Addendum No. 1

Contract No.: DA00169

WBS No.: 42999.3.1

*Drainage, Grading and Paving to improve curve radius on SR 1227 (South Mills Rd.),
Currituck County*

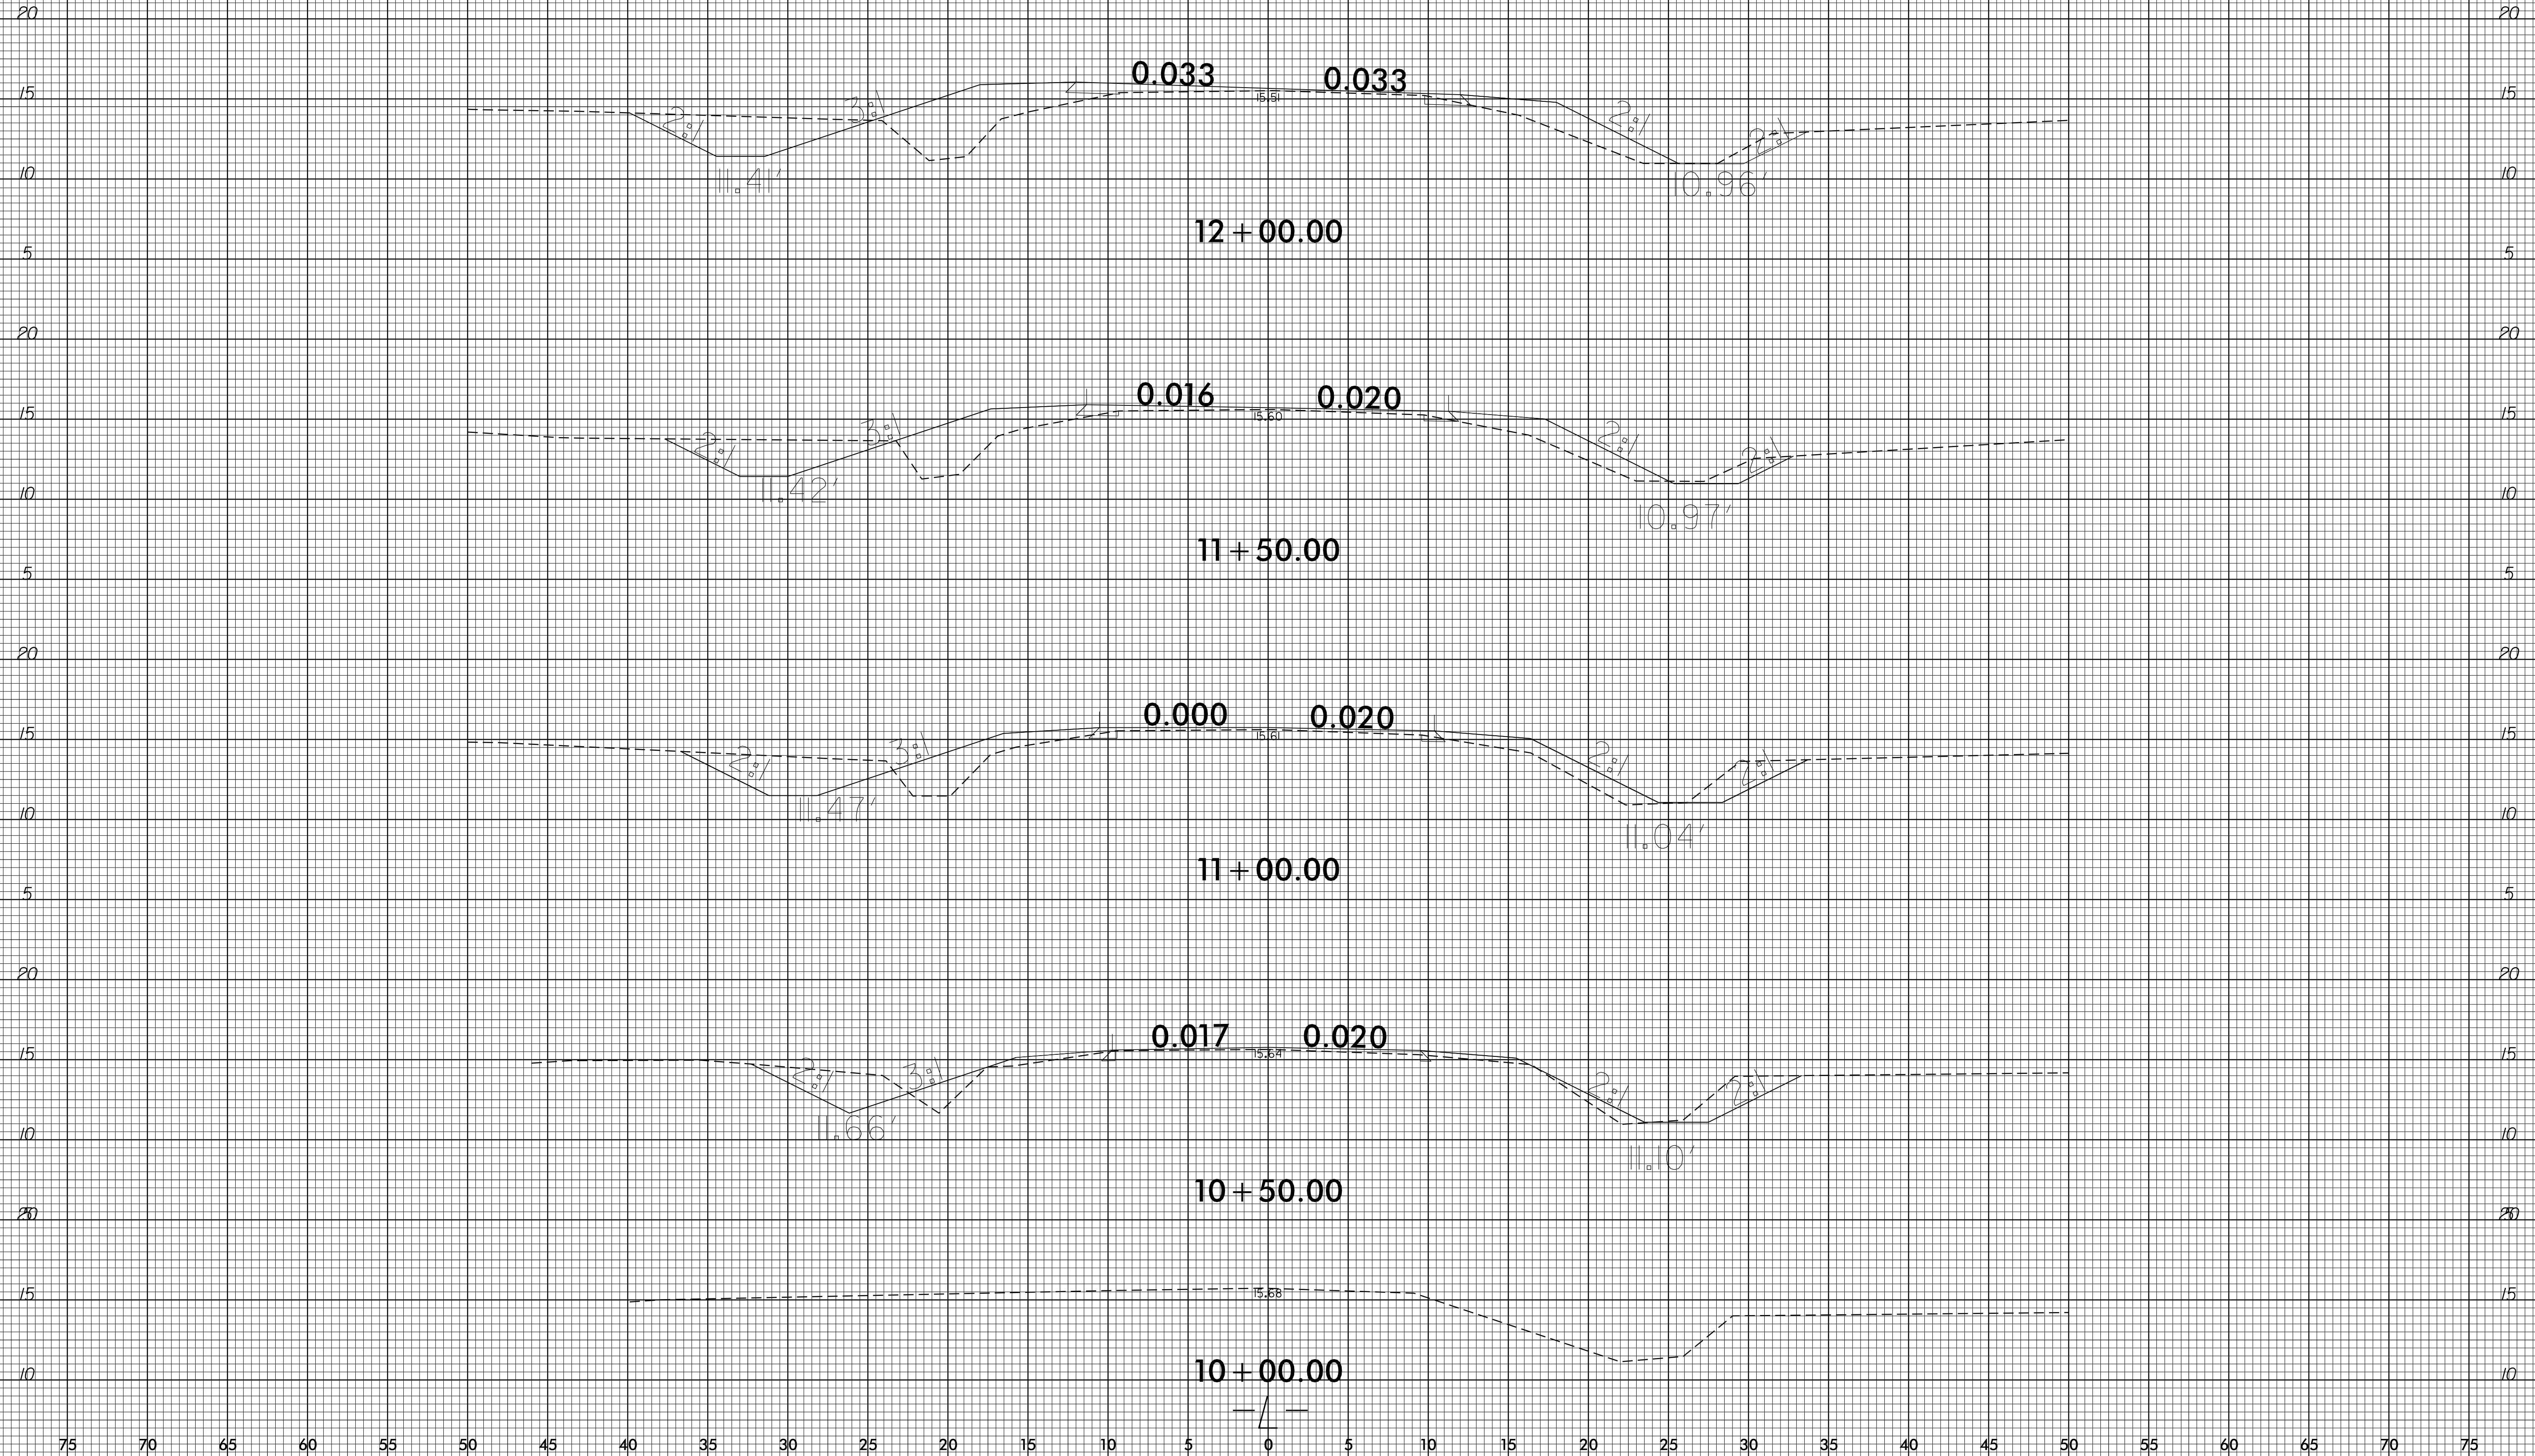
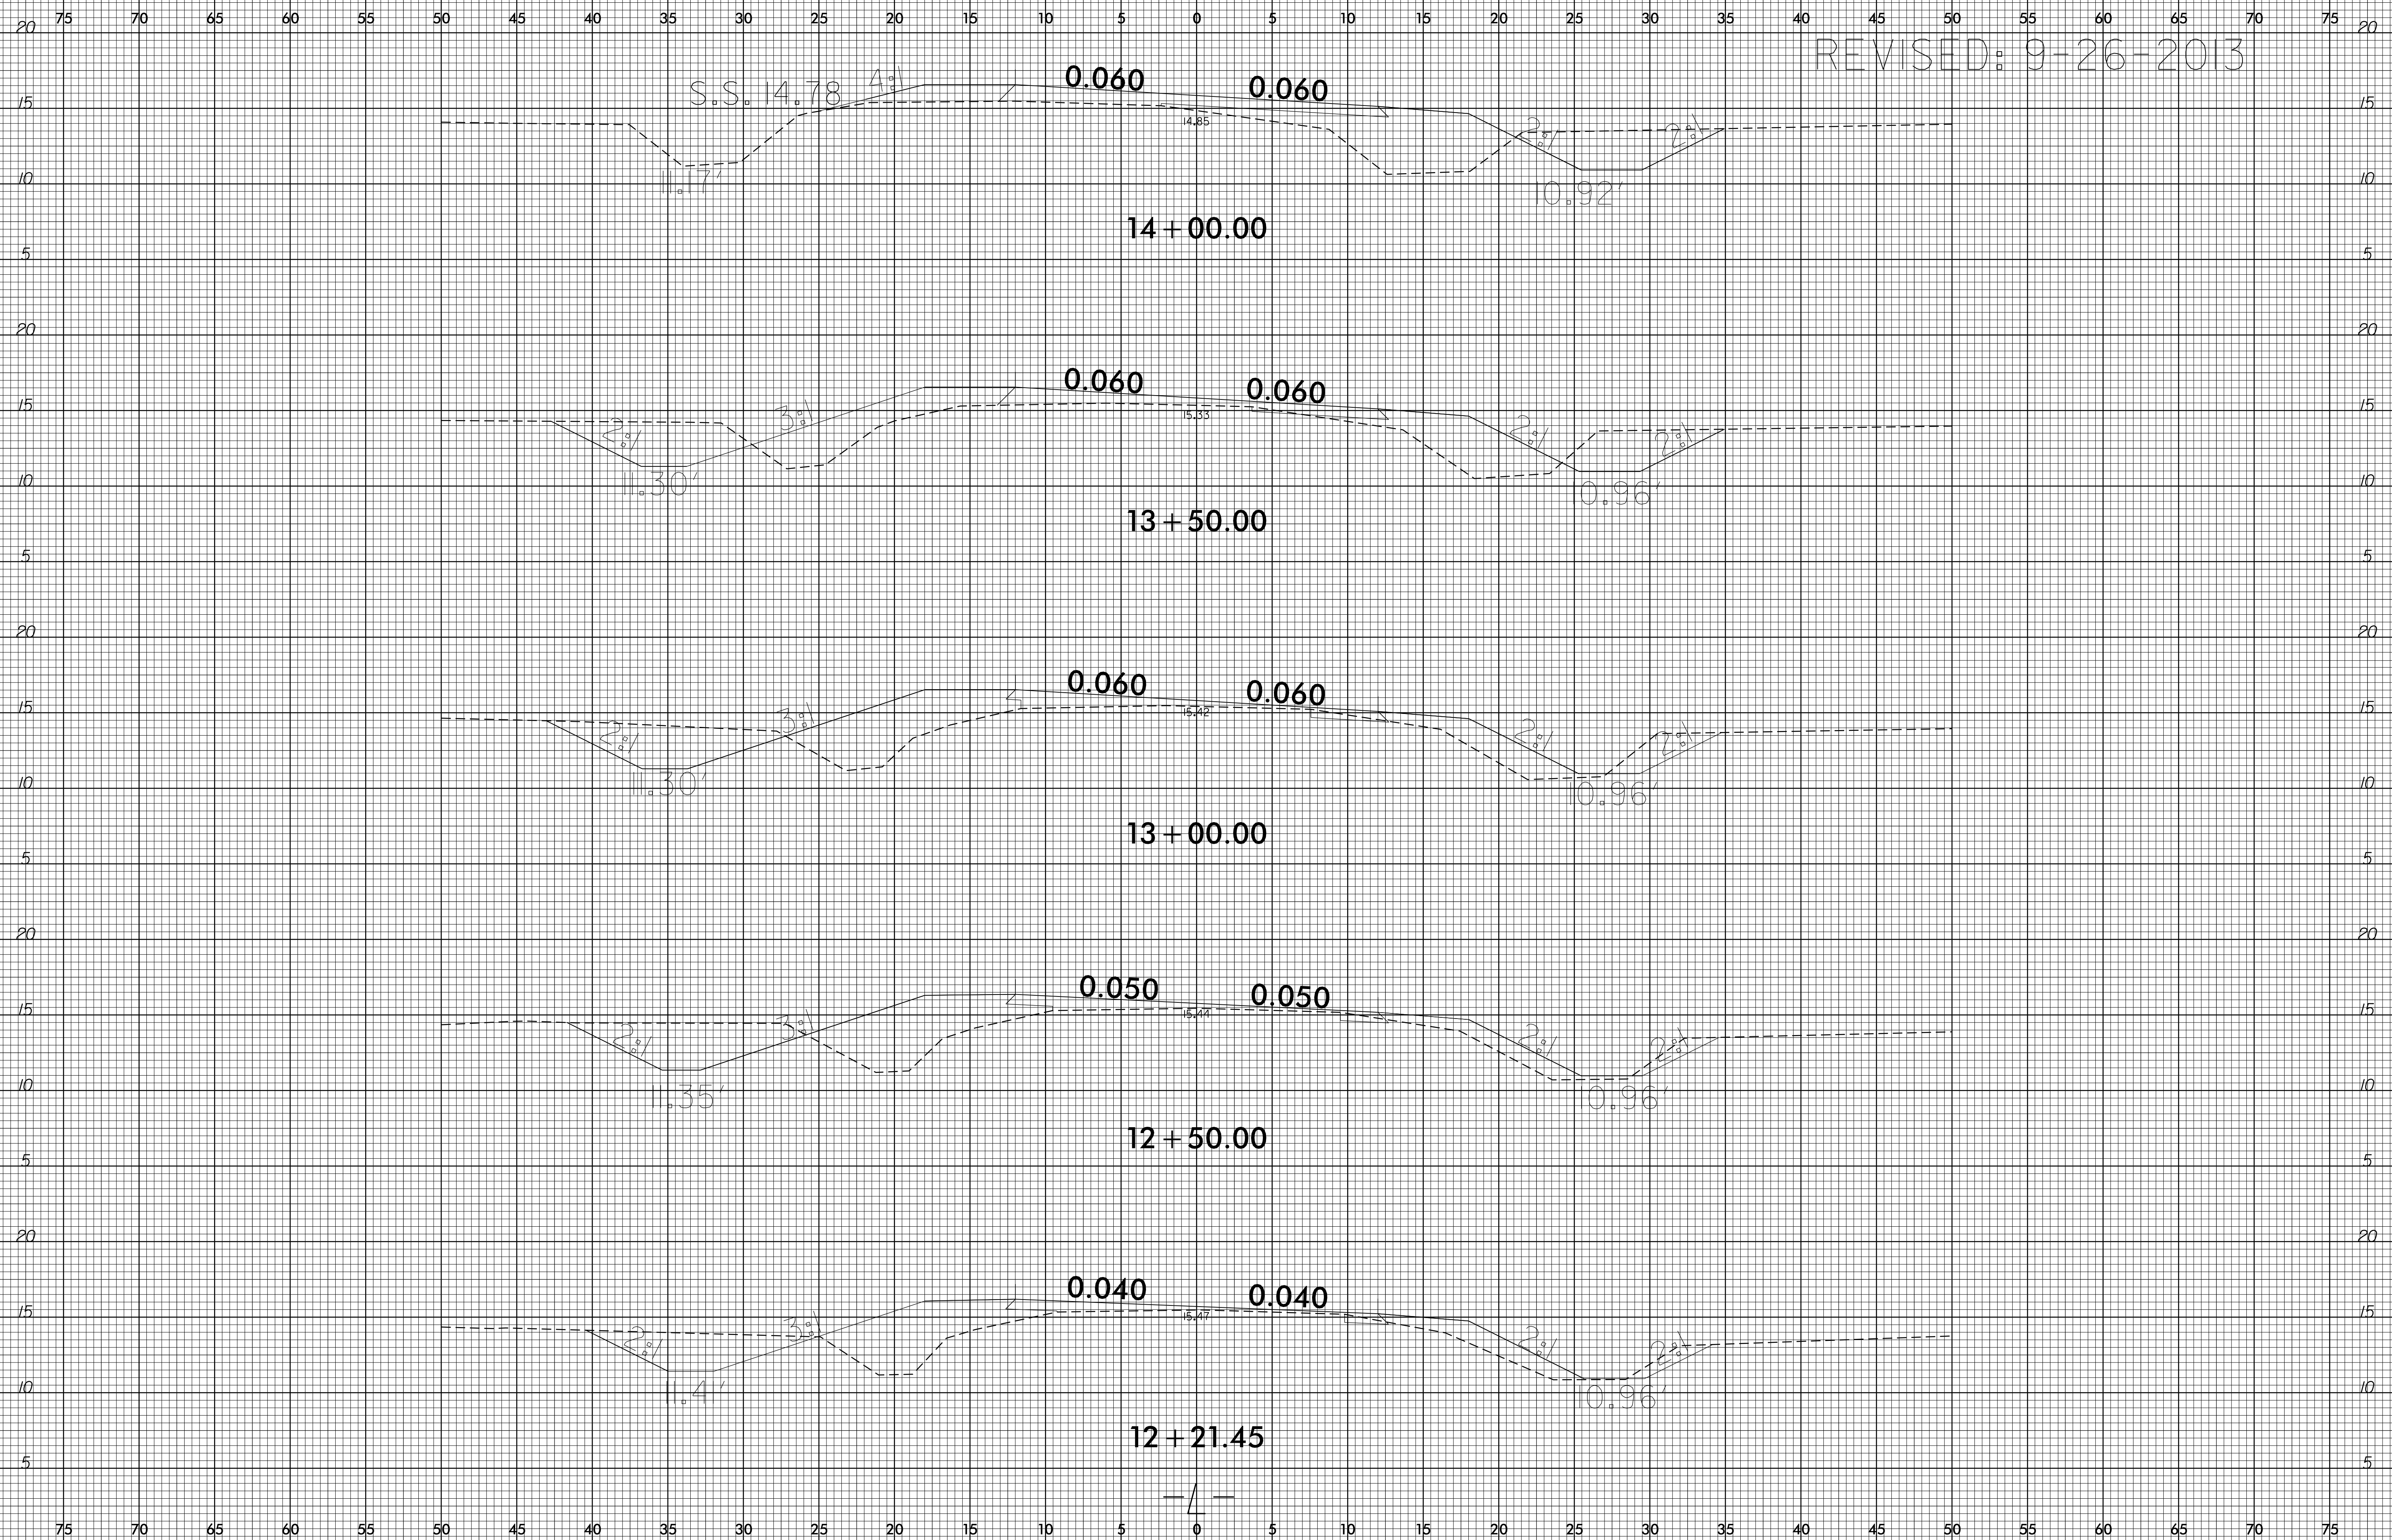
Plan Sheets X-1 to X-5 have been updated to illustrate the revised centerline profile." Please void the existing Plan Sheets X-1 to X-5, in the proposal and staple revised Plan Sheets X-1 to X-5 thereto and acknowledge addendum on the Bid Form.
